## Artesian 230kV Substation Expansion Project CPUC Minor Project Refinement Form

Report No.: MPR-5

Z12543 – Bypass Switch 689-3  
N: 33.08649°; W: -117.07211°  
Intersection of Cranston Drive and S Centre City Parkway

**Photograph # 3**

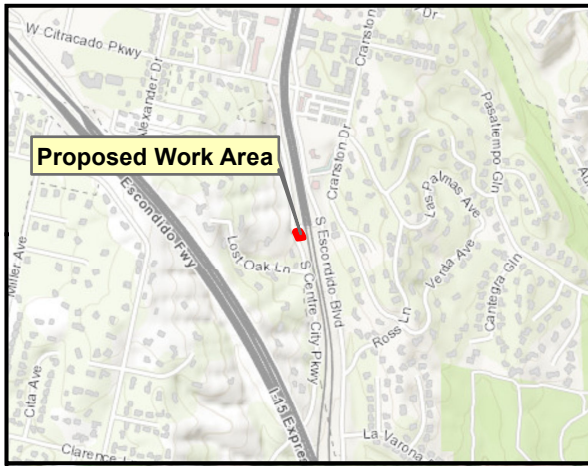
View of disturbed habitat and coastal sage scrub surrounding pole.
